**TECHNICAL ENFORCEMENT SUPPORT
AT HAZARDOUS WASTE SITES**

CDM Federal Programs Corporation

TABLE OF CONTENTS

A remedial investigation and the beginnings of a feasibility study (FS) have been conducted in three phases at the Universal Oil Products (UOP) site in East Rutherford, New Jersey. Volatile and semi-volatile compounds are widespread in high concentrations at the site. Polychlorinated biphenyls and inorganics are found in several areas of the site.

Cross-Section A-A

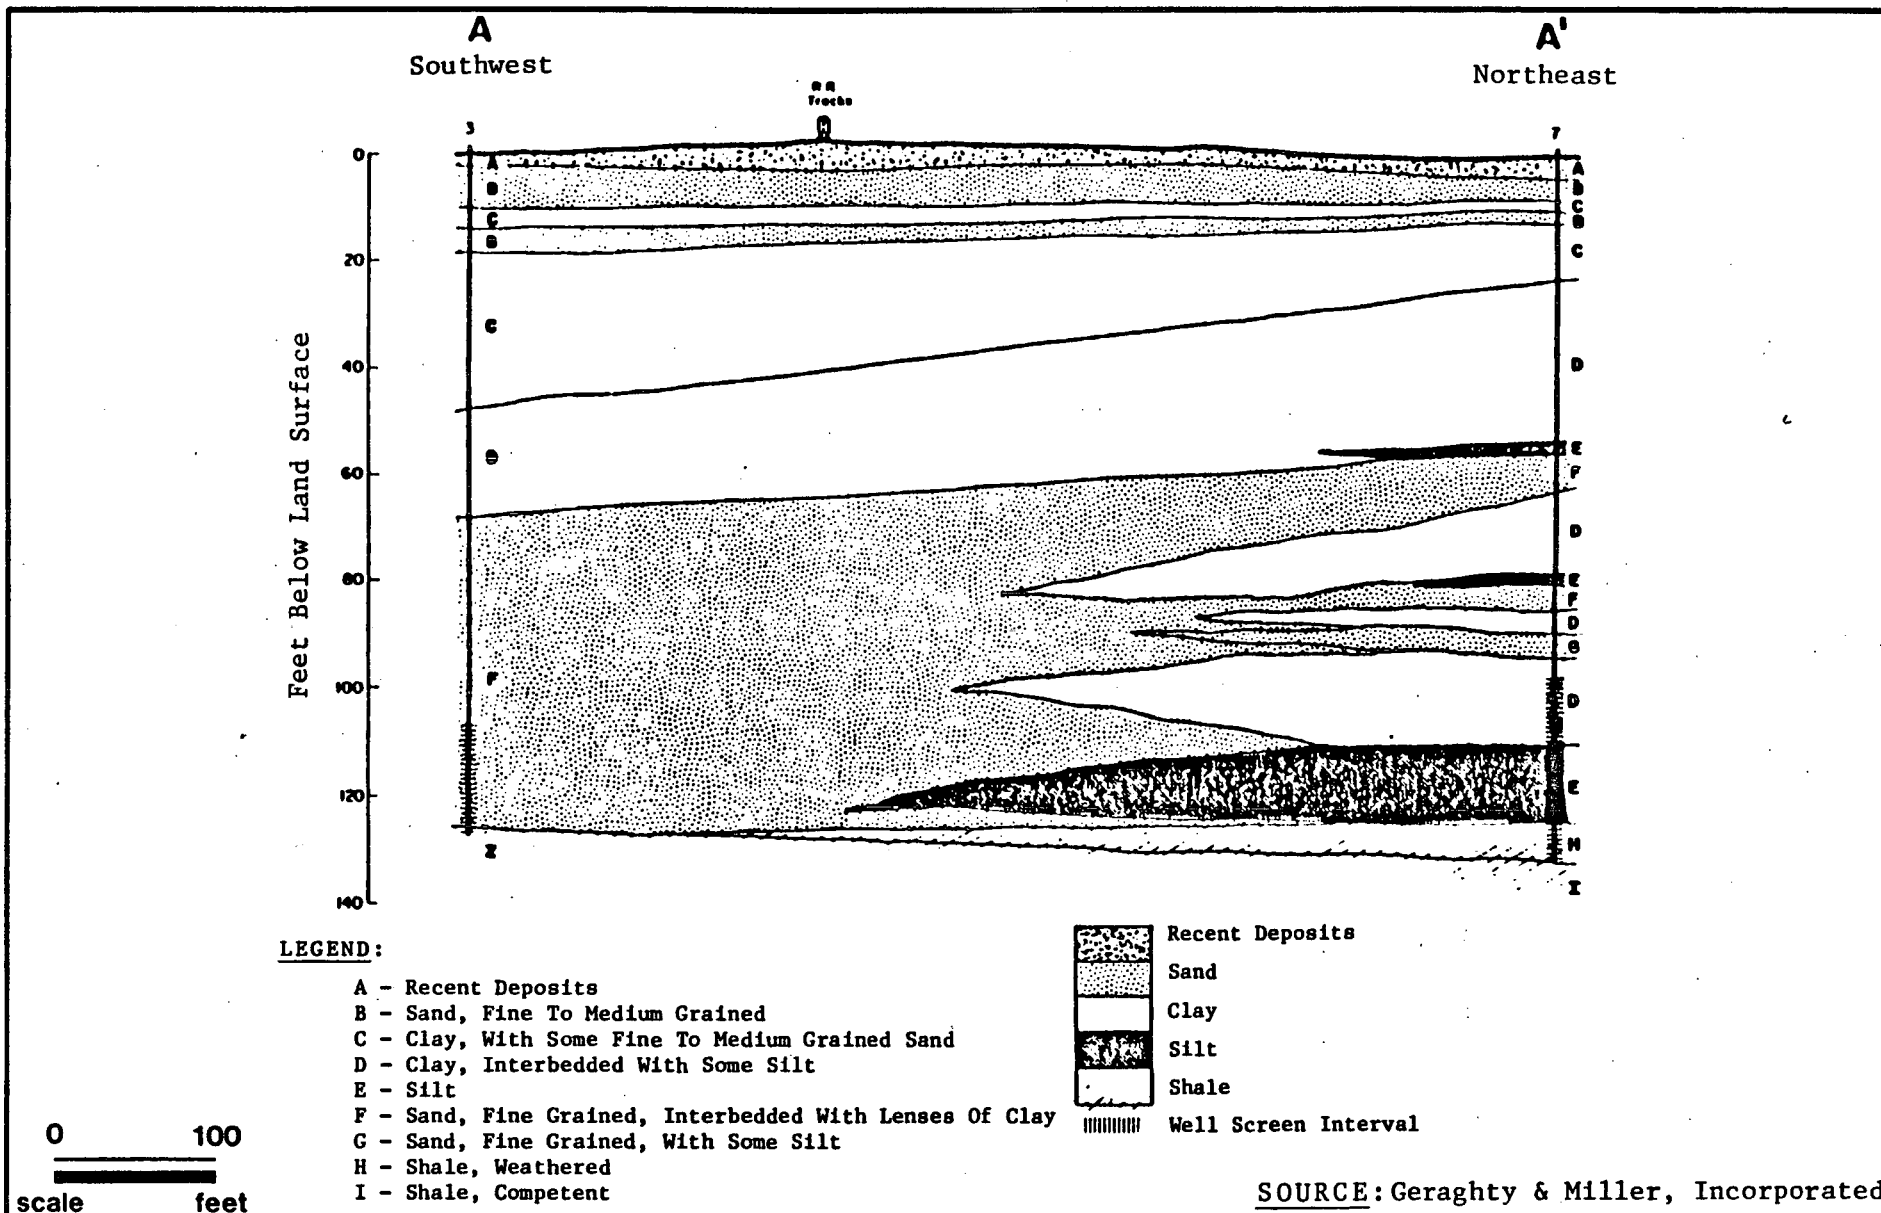
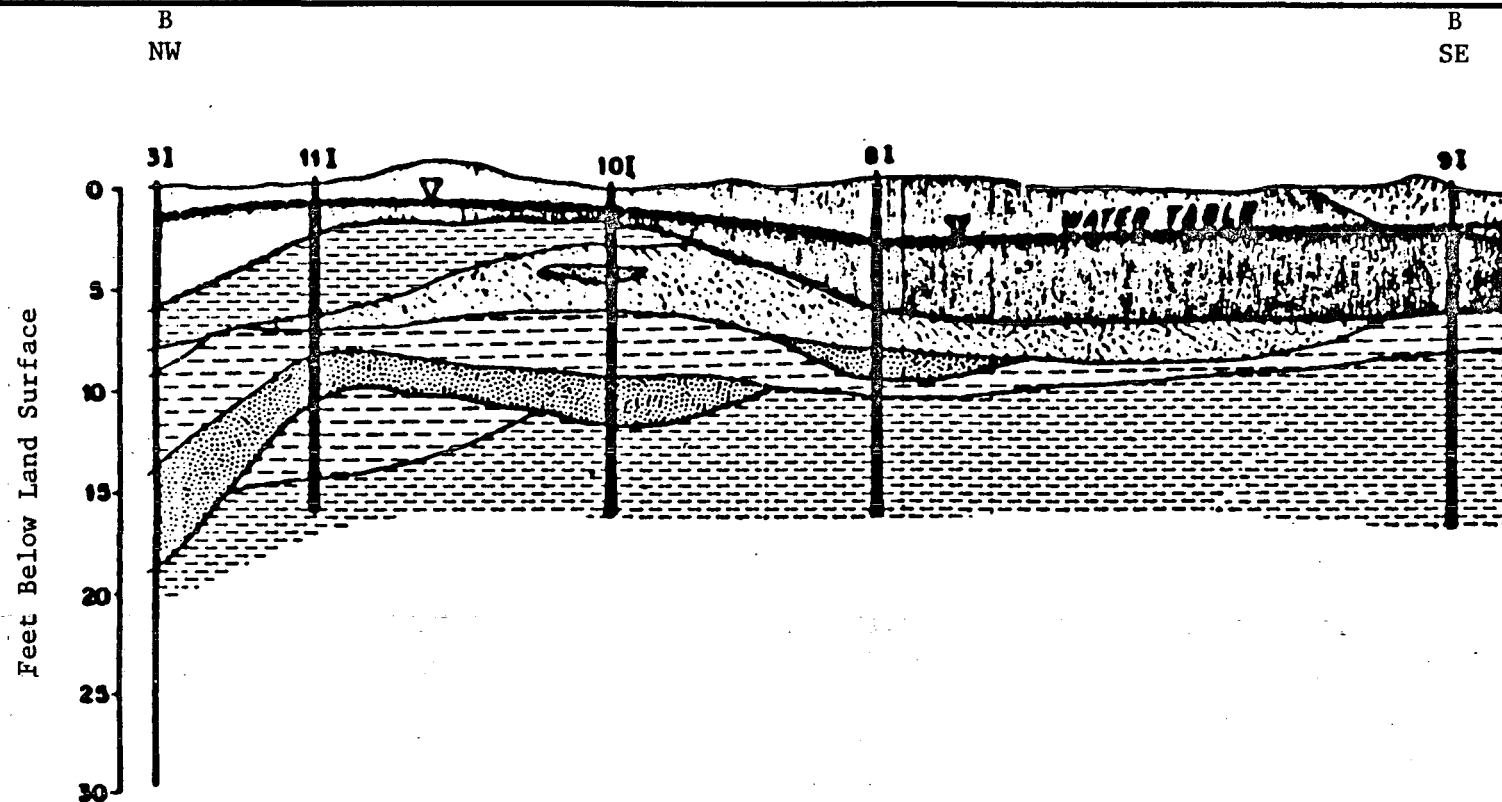
Need a map showing cross-sections A-A' & B-B'

Water Table Contours

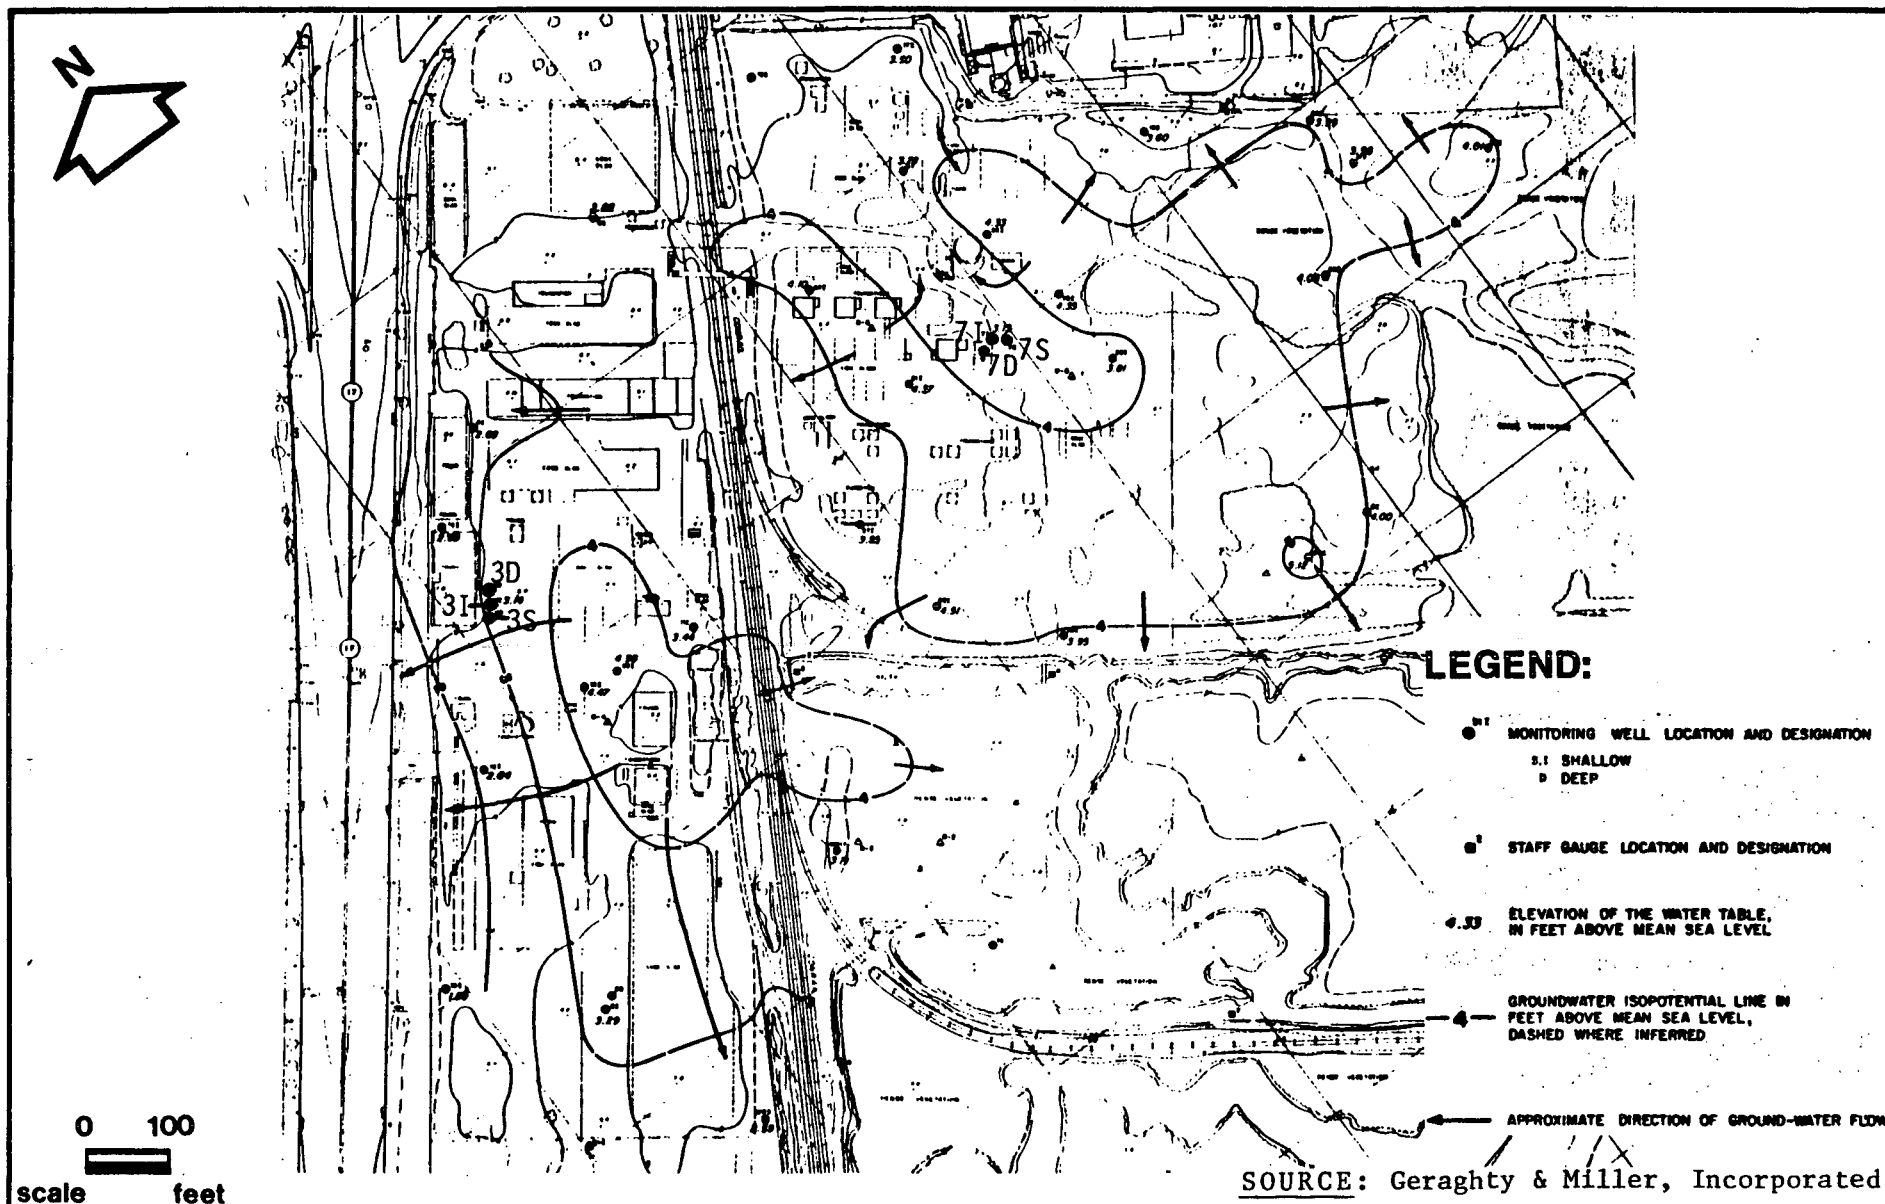
A net upward flow throughout the site has not been established, although it probably exists at the two locations where deep wells were installed (3D and 7D, Figure 5). The existence of low levels of contamination in both deep wells may refute the theory that the purported upward gradient is protecting the lower aquifer.

At least 3 more deep wells should be drilled in order to completely evaluate the hydrogeologic condition at UOP. One these wells should be placed slightly downgrade of an area where the shallow system is highly contaminated, specifically in Area 3, near the wastewater lagoons, or in Area 1A, northeast of Ackerman's Creek and southwest of Well Cluster 7. A third additional well should be drilled in an area where the shallow system is proven to be relatively uncontaminated, e.g. north of Area 1A and northeast of Area 2. An analysis of the ground water from this well would act as a background value for determining if contamination in the deep aquifer is due to on-site pumping. These additional wells would also help to determine the extent and thickness of the clay unit which is apparently confining the lower aquifer. At least one more well cluster would help to determine if the upward hydraulic gradient and low permeability of the clay unit is sufficient throughout the site to overcome diffusion of contaminants.

Volatile Organic Compounds In Ground Water
1985 - 1986

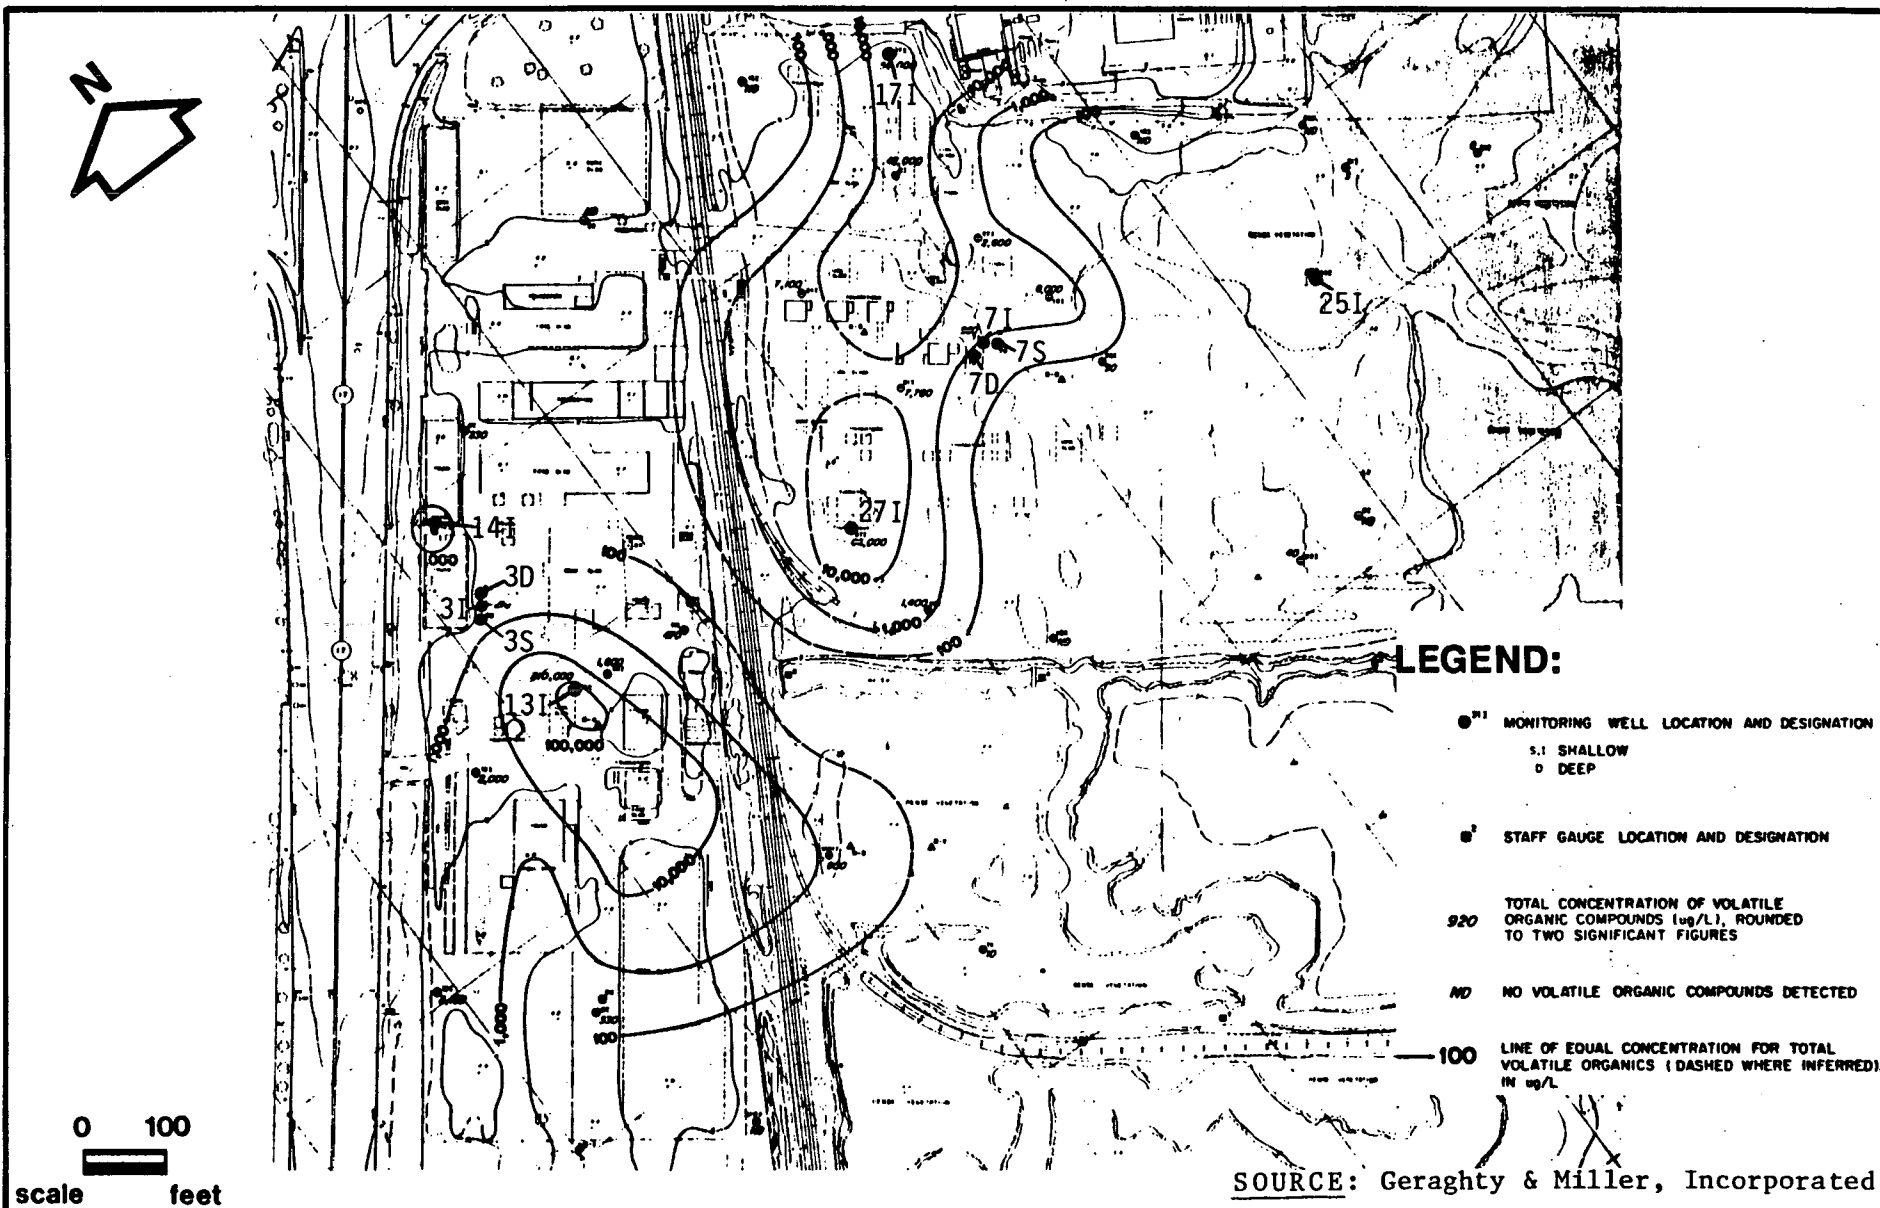
G&M stated that VOCs are notably absent in Area 5. However, the fact that the VOC's are much higher in Areas 1, 1A, and 2 than in Area 5 does not negate their presence in Area 5. The ground water VOC contour map (Figure 6) is misleading. The data suggests that the 1,000 ppb and 100 ppb isopleths in Area 2 may be drawn to the north rather than to the west, as G&M has done. If drawn to the north, then the need to sample off-site is further exemplified. A 100 ppb isopleth could be drawn in the eastern portion of Area 5, around Well 25I. Furthermore, for clarity, if a sample was not taken from a well, this should, in the future be symbolized on the map (e.g. NS for "not sampled"). Finally, it is difficult to place contamination in the Lagoons relative to the rest of the site because they are not located in any of the RI figures.

The highest VOC and BNA concentrations have been detected in the shallow aquifer at the northern and northeastern boundaries (Area 2 and 1A), but sampling was limited to the site boundary during the investigation. Additional ground water, soil, and surface water sampling beyond site boundaries is necessary to determine the extent of contamination. The shallow aquifer flow pattern supports the need to sample off-site to the north, northeast, and west of the site boundary (Figure 6).

Figure 9
Base/Neutral And Acid Extractable
Organic Compounds In Soils
1983 - 1986
UOP Site
East Rutherford, New Jersey

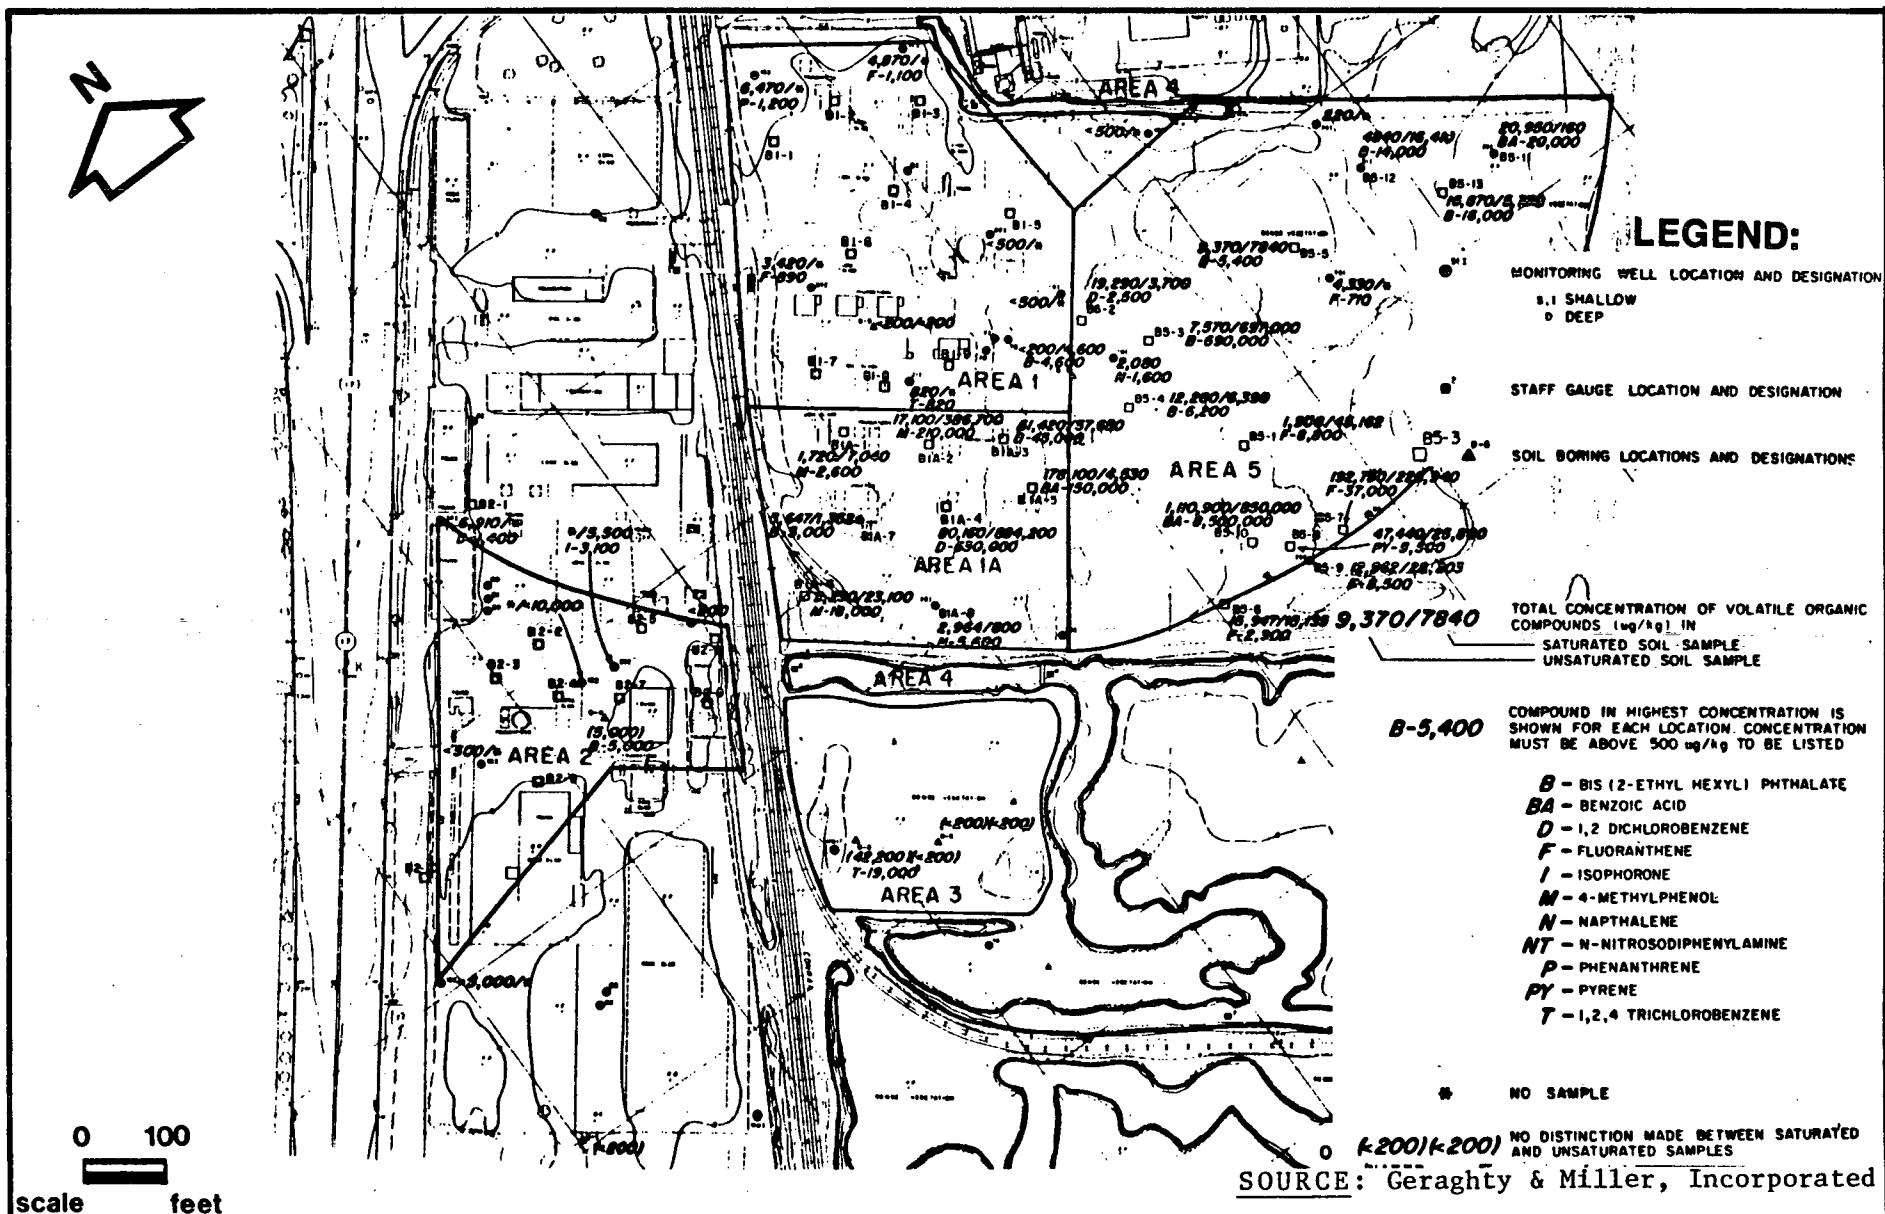
BNAs are present in the upper aquifer at up to 21,000 ppb (Well 13I) and seem to be located around six areas (see Figure 9). BNAs were also detected in low levels (<50 ppb) in both of the deep Wells. BNAs have been detected in parts per million at the site boundary and extend northeast and north from the site for an undetermined distance.
